SITE PLAN
DETACHED GARAGE
11712 FLAP JACK LANE
EL PASO COUNTY, CO
FOR: MASTERBILT HOMES

DRAWN BY: CH
DESIGNED BY: CH
CHECKED BY:
DATE: 6/17/26
SCALE: AS SHOWN
JOB NO.: 260118
SHEET NO.: SITE

V1_Site Plan Drawing.pdf Markup Summary

SITE PLAN

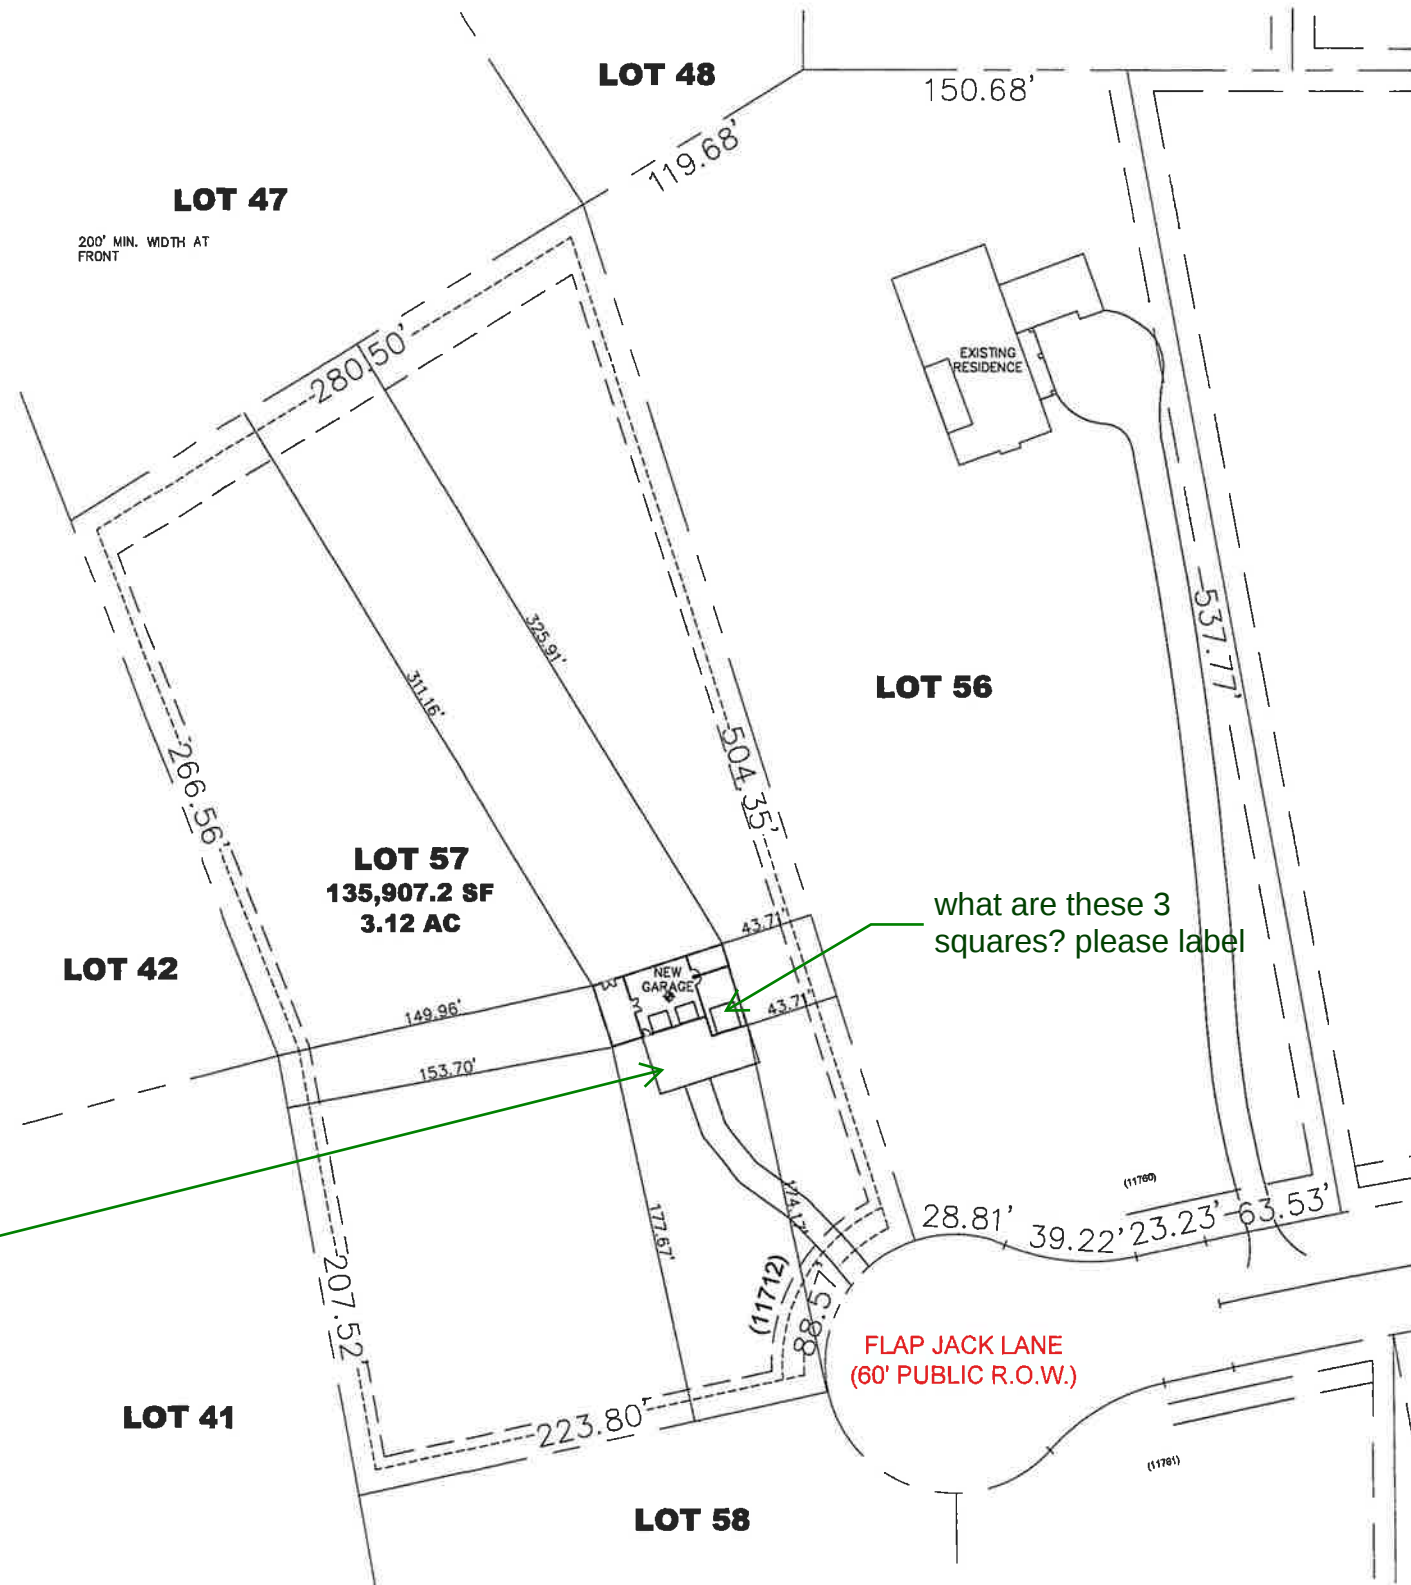
Please correct zoning
to RR2.5

Please add a note:
Garage is for
personal residential
use supporting Lot 56
only.

Please dimension
building,
Please add surface of
driveway and width.

A driveway permit will
be required

what are these 3 squares? please label
